STERLING RANCH EAST FILING NO. 5

SHEET 1 OF 5
JUNE 1, 2024
JOB NO. 1183.25
STERLING RANCH EAST FILING NO. 5

V1_Final Plat Drawings.pdf Markup Summary

SHEET 5 OF 5
JUNE 1, 2024
JOB NO. 1183.25
STERLING RANCH
EAST FILING NO. 5

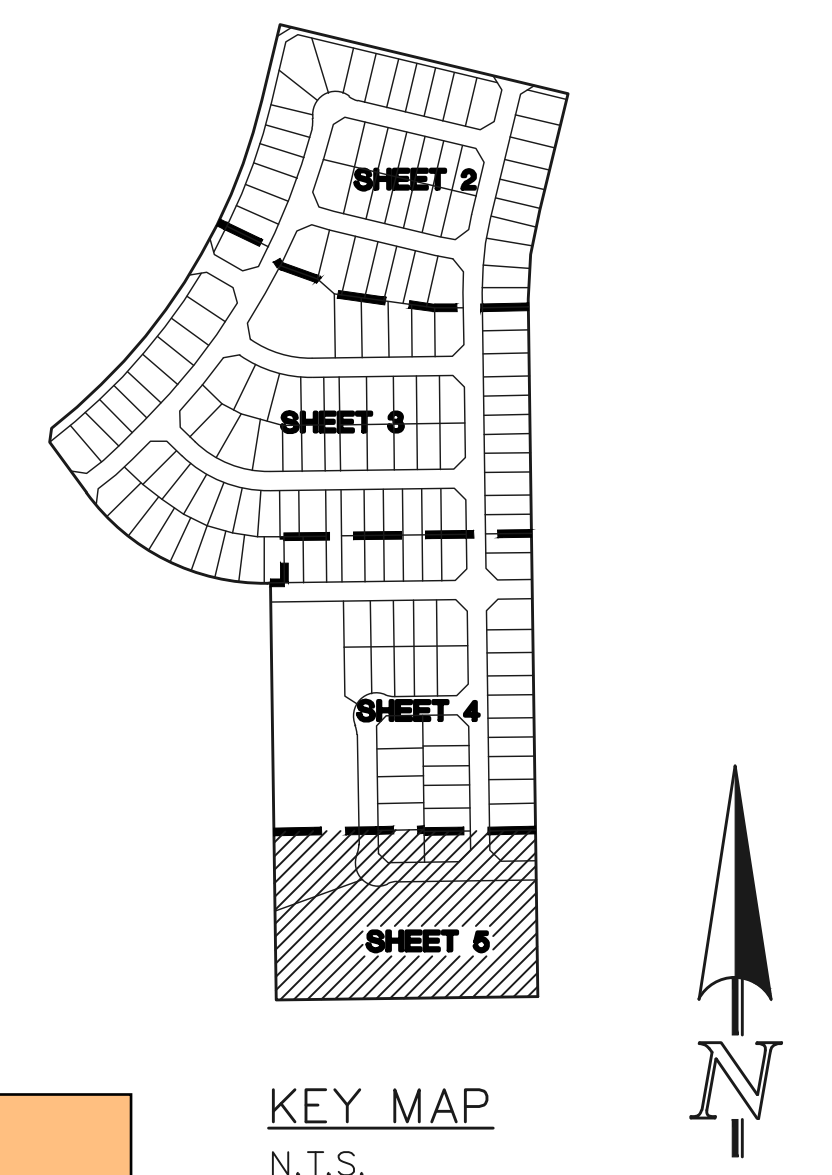
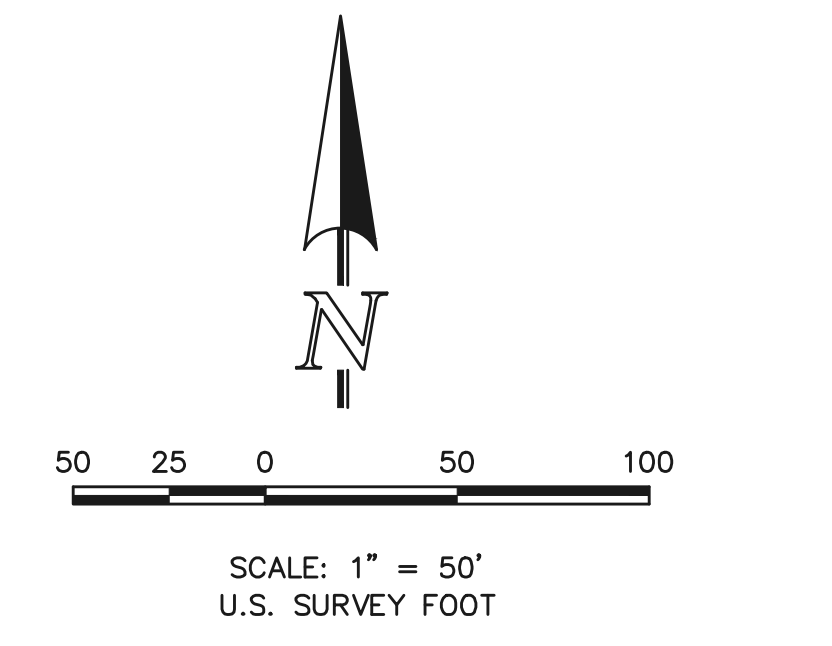
Per my comments in the FDR:
SPAs need to be in no-build drainage easements or tracts.
All of Basin Y1 is not within Tract A, some is within Lots 86 and 87 west of Tract A. So that area of those two lots will need to be shown as no-build easements on the Final Plat of that Filing (SR East F3).
Similar comment for the portion of Basin Y2 that is east of Tract A in the future SR filing.

Per my comments in the FDR:

SPAs need to be in no-build drainage easements
or tracts.

All of Basin Y1 is not within Tract A, some is within
Lots 86 and 87 west of Tract A. So that area of
those two lots will need to be shown as no-build
easements on the Final Plat of that Filing (SR East
F3).

Similar comment for the portion of Basin Y2 that is
east of Tract A in the future SR filing.
